SERVICE BULLETIN

Concerning 4500 and 6000 Series English Mark Dart Games

February 3, 1987

Due to an error in printed board circuit layout, there is a
problem which may cause short life with the **SC146D** triac in both
the 4500 and 6000 series game. The error causes the current to
drive the lamp to be supplied from the gate of the triac instead
of the normal terminals. Due to the fact that the device is
considerably oversized, in normal operation (with the 4500) the
gate would handle the current even though the device was electri-
cally mounted on the printed circuit board upside down. The
failures were caused when the bulb burns out with the filament
falling across itself shorting and drawing a much higher current.
If the device had been on the board correctly, the 120 amp surge
capability of the triac would have most often saved the device
from failing.

Fig. 2 and 3 show before and after for the printed circuit board for the 4500: fig. 4 and 5 show the 6000.

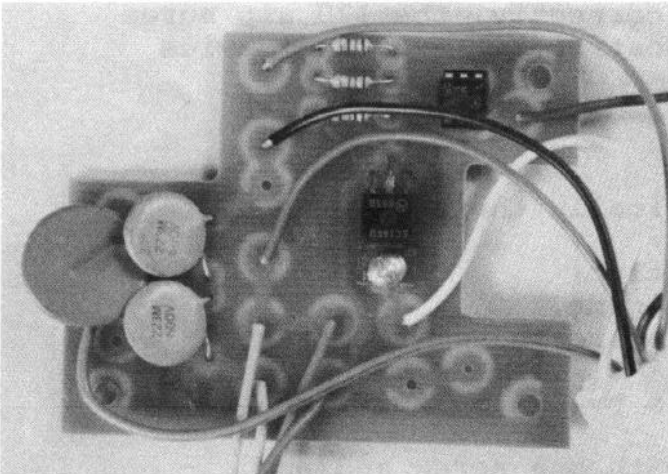
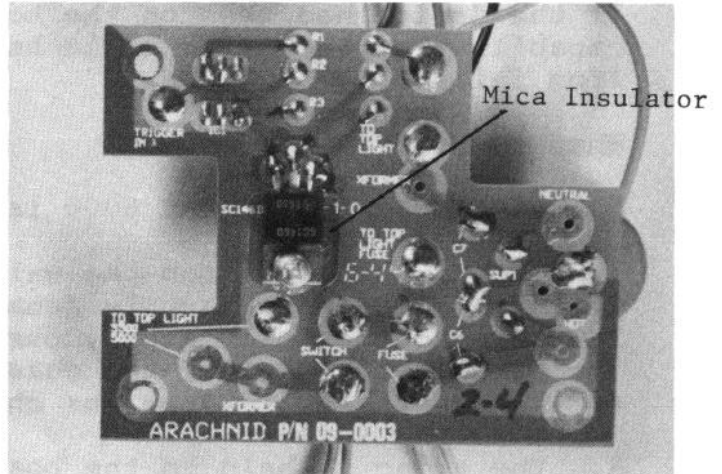
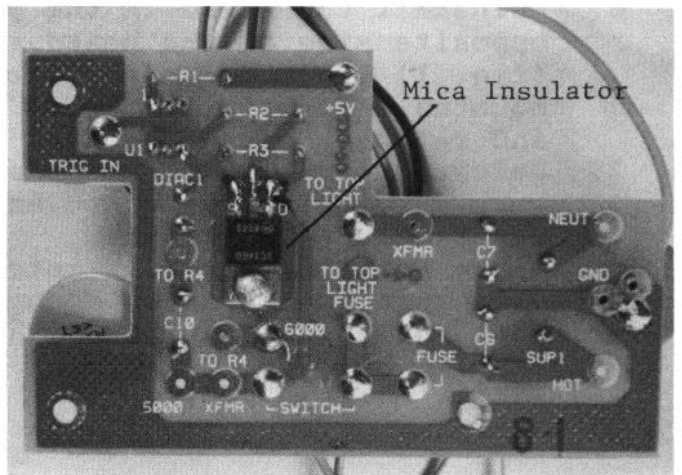
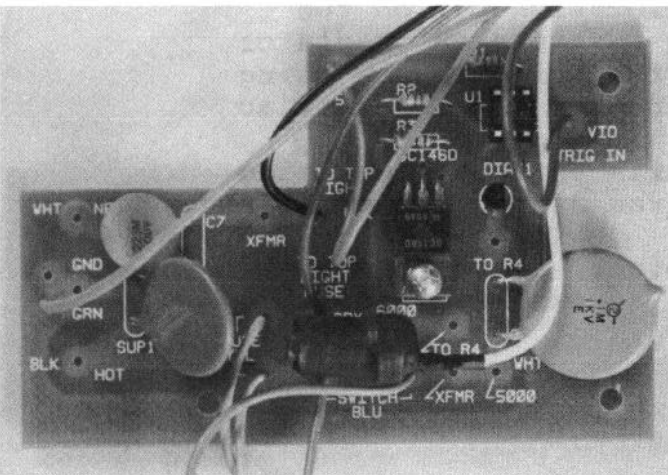
6. Reinstall the triac in the same location but on the
    opposite side of the board. You must use an insulator
    (fig. 1) since the metal tab of the triac is now being
    mounted on the foil side of the board. Resolder triac
    and reinsert screw and nut.

The fix for the 4500 and 6000 is basically the same.

1. Unplug the game from the wall outlet1
2. Remove the power supply from the game.
3. Turning the power supply over, locate the small printed
    circuit board under the chassis.

4. Remove the board from the chassis by unscrewing three
    mounting screws.
5. The triac is held to the board with one screw and nut.
    Remove screw and carefully unsolder the triac from PC
    board.

7. Reinstall PC board into **chasis** with three screws being
    very careful not to pinch any wires as you are tightening
    them.
8. Place power supply back into cabinet, attach plugs from
    wire harnesses, fasten down with screws, and plug into
    wall outlet.

6000 lamp

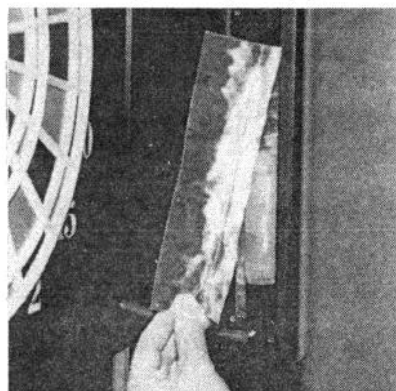
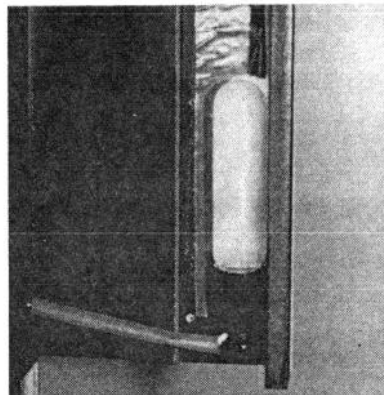
To update the 6000 series game to use the shorter 5 1/2" T-10 40 watt lamps instead of the 11 1/2" T-8 40 watt lamps, you will need to do the following:

1. Move the (2) lamp sockets located on the sides down to the lower end of the shadow box. The crimp-on connectors will have to be removed by cutting as close as possible to the connector located inside the back of the game. Wire nuts will be used to refasten these wires. The socket will bc pointing up instead of down. The screw for the socket should be located about one inch up from the lower edge. A new hole will have to be drilled into the back panel for the wires. This can be done from the back of the game (plan ahead to get the holes in the right spot). The Arachnid part number on this lamp is 11-0007.

2. Aluminum reflective foil with adhesive back (commonly available from an automotive supply store) <u>MUST</u> be installed between the lamp and the wood shadow box for two reasons:

Although the short bulbs can be installed without moving the sockets down, the aluminum tape <u>MUST</u> bc used due to the increased heat of the shorter bulb. Moving the sockets down helps to distribute the light more evenly.

The foil that WC arc using is 2 5/8" x 9" and is bent into an "L" (the long direction) before inserting in the shadow box. The part number from Arachnid for the foil is 13-0069.

FIG.1

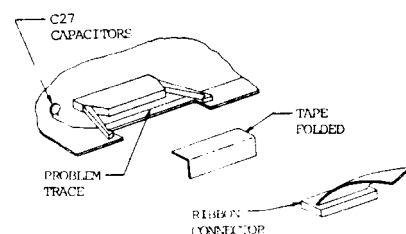
A problem has arisen concerning the location rhere the target inter-face board ribbon cable connects into the **main** P.C.board on the 6000 and Super 6 Plus games. Apparently, the trace that runs the control-ling voltage for the target **lamps** is located directly beneath the area where this ribbon cable **is** plugged in. There is a thin coating of insulating film covering this trace, but after a period of **time** this coating can rear off, leaving the copper trace exposed. Due to the construction of the Target Interface ribbon cable, vhen the coating is no longer present, the rav edges of the ribbon say make contact vith this copper trace, **vhich** can cause target **lamp flickering,** sinulate a stuck segment, or simulate a throvn dart. A stuck segment simulation locks up the **game** if the ribbon sakes constant contact, but **many times** the ribbon **vill** short momentarily when a vibration occurs to the P.C. board, such as vhen throving a dart or touching the Select or Player Change buttons. This type of short say result In the game shoving an extra dart throvn In a round, or the gase nay reset during play.

1. Turn off gane, and unplug fros wall outlet!
2. Disconnect the ribbon cable **coming** from the T.I.board to the main **P.C.board.(see** fig.11
3. Locate the trace that runs **belov** the ribbon **connector.(see** fig.11
4. Using a piece of electrical tape, cover the trace completely at the connector location, and fold tape down over the P.C. board edge (to keep connector from catching on tape).
5. Re-insert the ribbon cable into the header on the main P.C.board.
6. Plug game into the **vall,** and turn it on.
7. When servicing the game in the future, periodically check the placement of the tape, to be sure it has not shifted.

Figure 1
D.I.P. Switch Location on Main P.C. Board, CPS side, 6000 & 7000 Series Games-

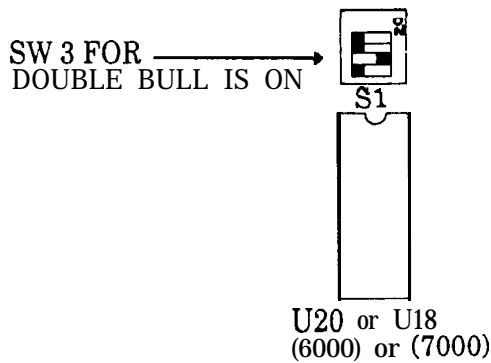
On 6000 and 7000 series games, there is a 4 position Dip Switch on the main P.C. Board. Some older 6000 games may not have this switch installed. It should be located just above U20 on your 6000 main P.C. Board (Above U18 on 7000 P.C. boards). Install one if it is not there already. Flipping SW3 of this Dip Switch (see Figure 1) will activate or deactivate the Double Bull. SW3 ON = Double Bull ON; SW3 OFF = Double Bull OFF (Single 50 point Bull is on). See your owners manual for other switch functions.

Figure 3
P.C. BOARD, SOLDER SIDE
4500 AND 4800 SERIES

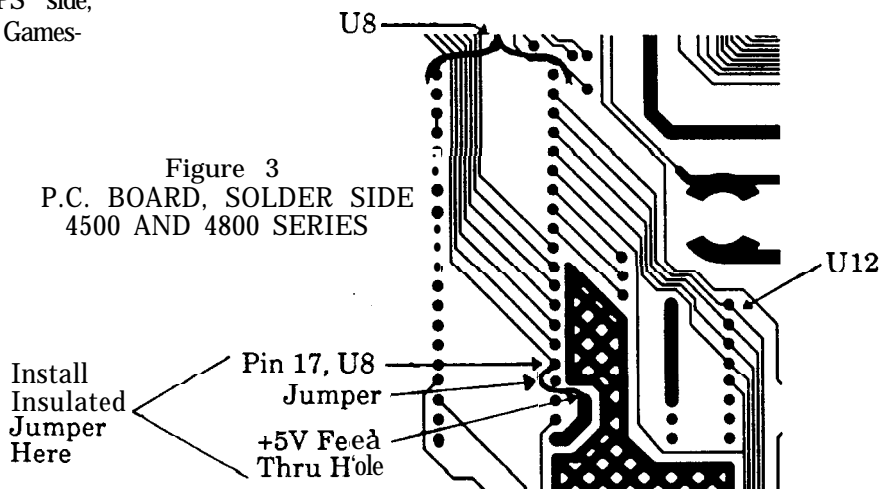
To activate the Double Bull option, run a jumper from pin 17 of U8 to +5V. This can be done as shown in Figure 3. Some newer games (in 4800 Series) may have a switch installed on the P-C. Board. If so it will be located near U8, on the solder side. of the P.C. board. Simply flip it to the "on" or "up" position. Figure 2 illustrates this.

Pin 17, U8
Jumper
+5V Feed
Thru Hole

FIGURE #2

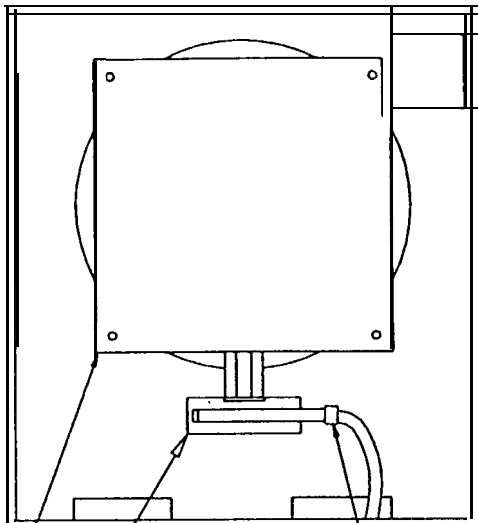
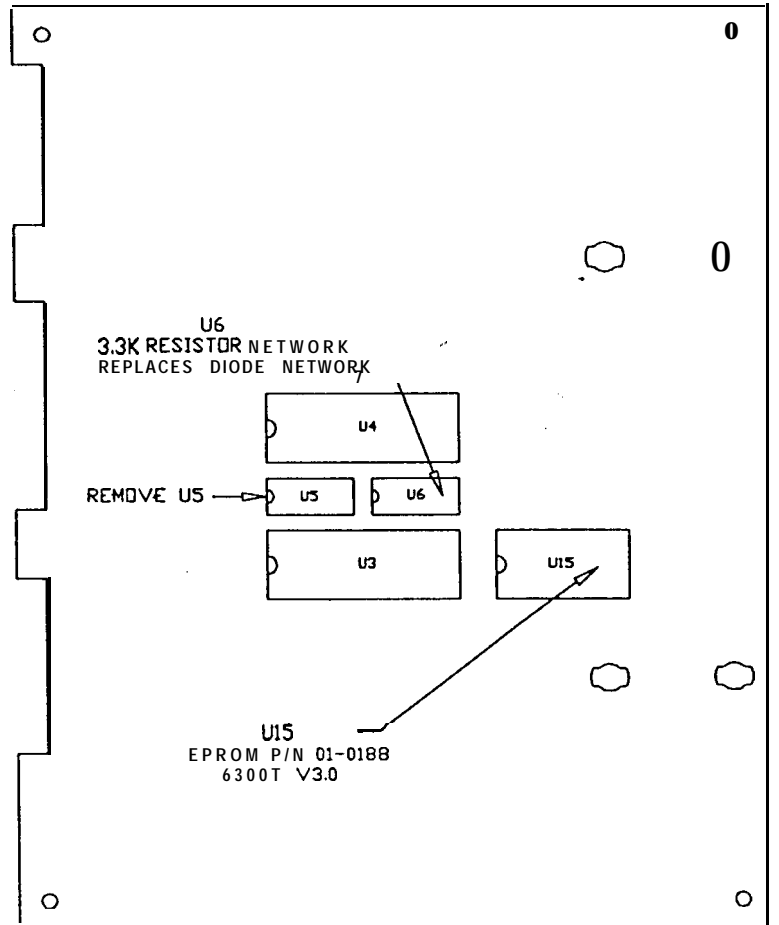
U6
3.3K RESISTOR NETWORK
REPLACES DIODE NETWORK

REMOVE U5 → U5   U6

U15
EPROM P/N 01-0188
6300T V3.0

Remove resistor network U5 **and diode network** U6. **Most boards do not have sockets for these chips so they must be unsoldered, Using a** small **side cutting pliers, cut all the legs of each chip and remove the body, Each individual pin can then be unsoldered and removed,**

Install **the new** 3.3K **resistor network chip** U6.

Remove the original EPROM from U15 **and** install **the new** V3.0 **EPROM at** U15.
